#### LC 66

In the Matter of PGE 2016 Integrated Resource Plan

Comments of Renewable Northwest

#### Figure 1—PGE 2016 IRP Formula for Calculating Durability across Futures<sup>44</sup>

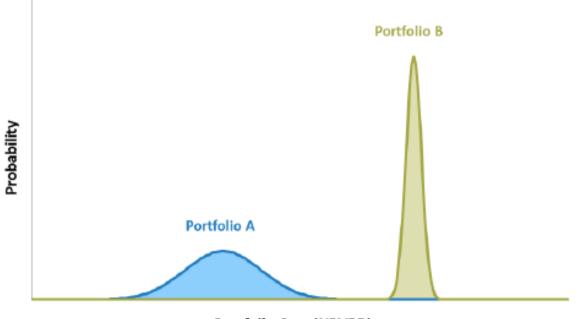
PGE's example helps illustrate some of the concerns with the use of durability. First, while durability may capture ordinal information (1<sup>st</sup>, 2<sup>nd</sup>, 3<sup>rd</sup> etc), it loses any cardinal information associated with cost (for example an NPVRR of \$31,319 million versus an NPVRR of \$31,875 million). Second, durability acts as a proxy for cost. If PGE's example was meant to illustrate the usefulness of the application of durability in the 2016 IRP, such an example does not characterize how *Efficient Thermal 2021* and *Wind 2018\_Long* compare to one another. While the difference in cost score between 2018 and 2021 is small, the difference in variability score is significant. This point is illustrated by the 77 cost score for Wind Long 2021, as compared to 100 points for Efficient Thermal 2021. In contrast, Efficient 2021 receives 0 points for variability while Wind long receives 100. The fact that durability brings Efficient Thermal 2021 to the top overall weighted score underscores the degree to which the metric acts as a proxy for cost. If the goal of an IRP were simply to identify the portfolio with the lowest NPVRR, this issue would not be problematic. However, the goal of an IRP is to identify the portfolio with the lowest cost and risk.

Renewable Northwest questions the usefulness of the durability metric. PGE states that the durability metric is "helpful" when two portfolios may have "similar total portfolio scores"<sup>49</sup> but "perform quite differently respect to cost and risk"<sup>50</sup>, suggesting in such a case that there is a need for additional analysis. This reasoning is problematic for two reasons:

1) in the case that two portfolios have the same score based on cost and risk, the implication should be that they achieve the same rank, without further need for parsing them out; furthermore,

2) durability already *is* one of the risk metrics, having equal weight with severity and variability, so it is unclear how the durability metric helps distinguish portfolios with the similar portfolio scores when the durability metric itself contributes to that score.

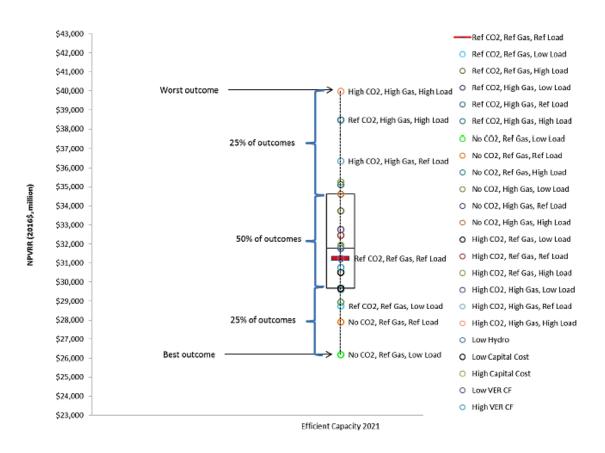
PGE did not conduct full "capacity expansion" modeling to form its candidate resource portfolios. These types of models are important because they review customer peak and energy demand, as well as current and projected resources, and build resources as required to meet those demands at lowest possible cost. Key conditions—such as natural gas and carbon prices—will affect not only how often existing resources are operated but also what capacity is added or retired. In turn, those changes affect the market prices of energy that PGE would buy or sell. For instance, if a utility knew that natural gas prices were going to skyrocket, it might think twice about planning to build a new natural gas generator. Typically, capacity expansion models are populated with a large number of supply-side (and sometimes demand-side) resources, and allowed to choose the least-cost mix of resources. Had the Company conducted this type of modeling, it could have rigorously tested the portfolio mix selected by the optimization model against different market conditions. Instead, the Company's portfolios are pre-determined, and much of the capacity added is little more than filler—modeled as natural gas combustion turbines (CC).

The Company's methodology is flawed because it does not take into account the full range of resources available to the Company, nor does it provide an indication which of the resources that might fall into the category of "generic" or "efficient" capacity are actually cost-effective. The Company assumes that retiring existing capacity (e.g. Boardman) would necessitate new natural gas construction, mostly ignoring the alternative of procuring existing resources, either outright or through power purchase agreements (PPAs). When capacity resources are not needed in the immediate future, the possibility of procuring other types of new resources should be incorporated into the scenario modeling. PGE's approach also does not allow for capacity to change with market conditions. As it stands, PGE is falsely limiting its

options. We recommend that the PGE conduct capacity expansion modeling to provide the Company with a more meaningful example of what it should be pursuing.
